Delmore Fast-Track

Memorandum – Specialist input: Healthy Waters

Subject: FTA159 – Delmore Fast Track – Auckland Council Application Reference: BUN60444768

Date: 25 June 2025

Figure 1. SMP - Figure 14: Treatment Train flow chart for BPO (McKenzie and Co – Feb 2025)

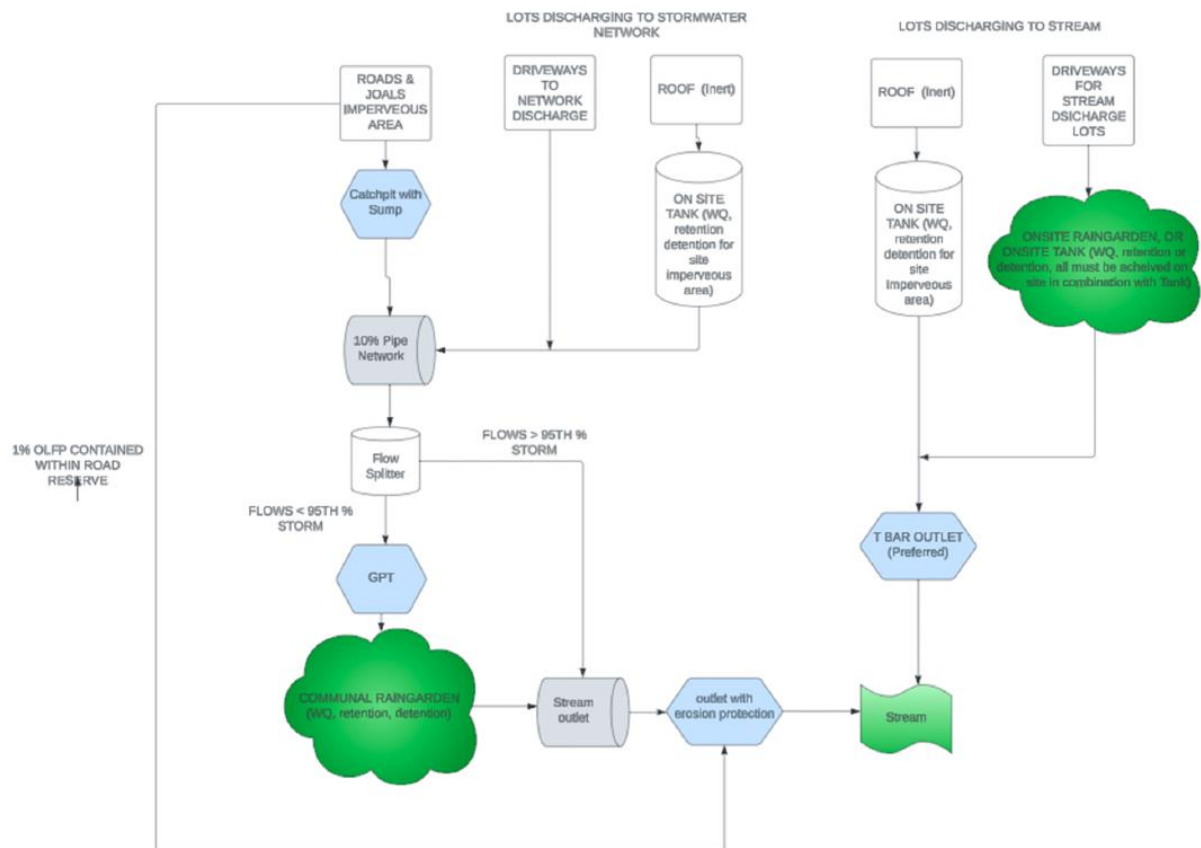
- 3.3 The SMP outlines a Treatment Train approach for stormwater management for the development as outlined within Figure 1. This does not fully align with the descriptions provided in the Infrastructure Report which may result in inappropriate implementation of the stormwater management solution for the development area. In relation to the roof tanks (plumbed for non-potable reuse), the implementation is described as optional. This requires clarification to ensure the stormwater management solution is implemented appropriately.
